# SITE PLAN REVIEW SHEET ENVIRONMENTAL VARIANCE REQUEST ONLY

CASE: SP-2018-0221C ZAP COMMISSION DATE: March 5<sup>th</sup>, 2019

**PROJECT NAME:** West Harbour Marina

The applicant proposes to replace existing boat dock cluster and bulkhead.

1. Cofferdam Locations for Heritage Tree Protection	p. 6
2. Table of Required and Proposed Mitigation Plantings	p. 7

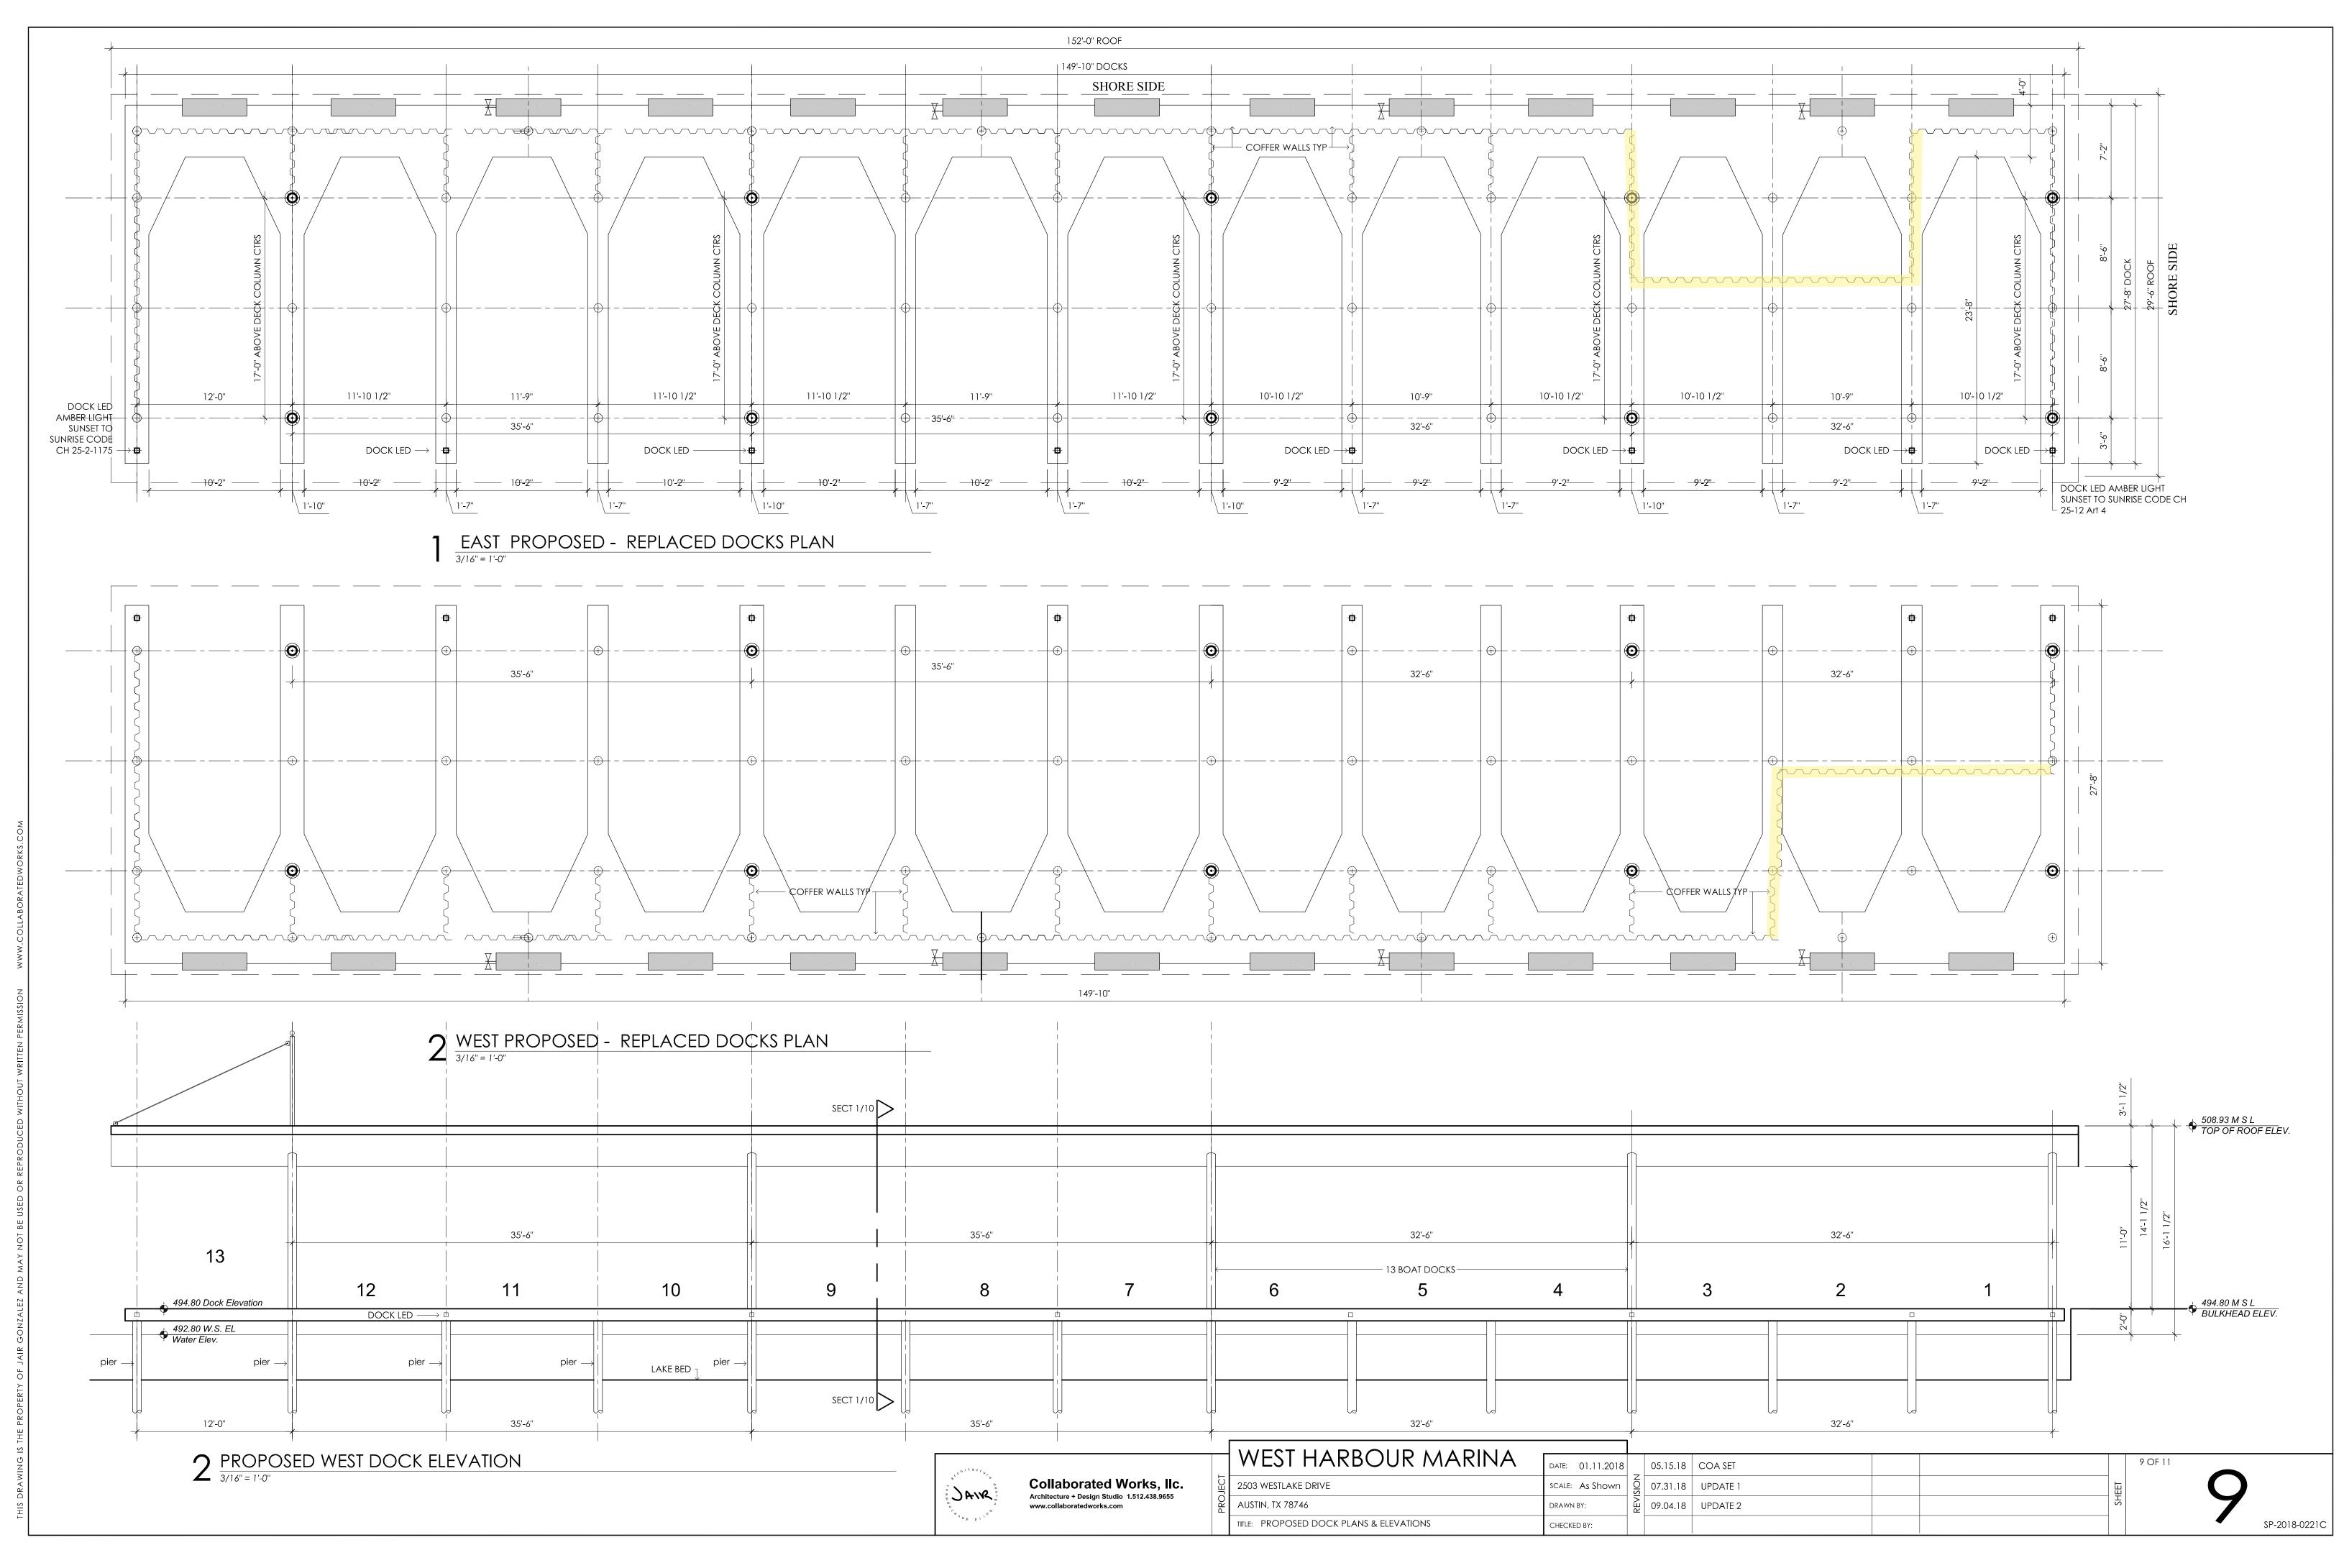
Staff determination is that the findings of fact have been met. Staff recommends the following conditions: 1) install cofferdams

before beginning dredging on the 4 slips adjacent to Heritage tree roots; 2) provide additional mitigation, beyond the requirements, for wetlands (32 additional plants), riparian restoration (7 additional 609S plants), and tree replacement (32 additional inches).
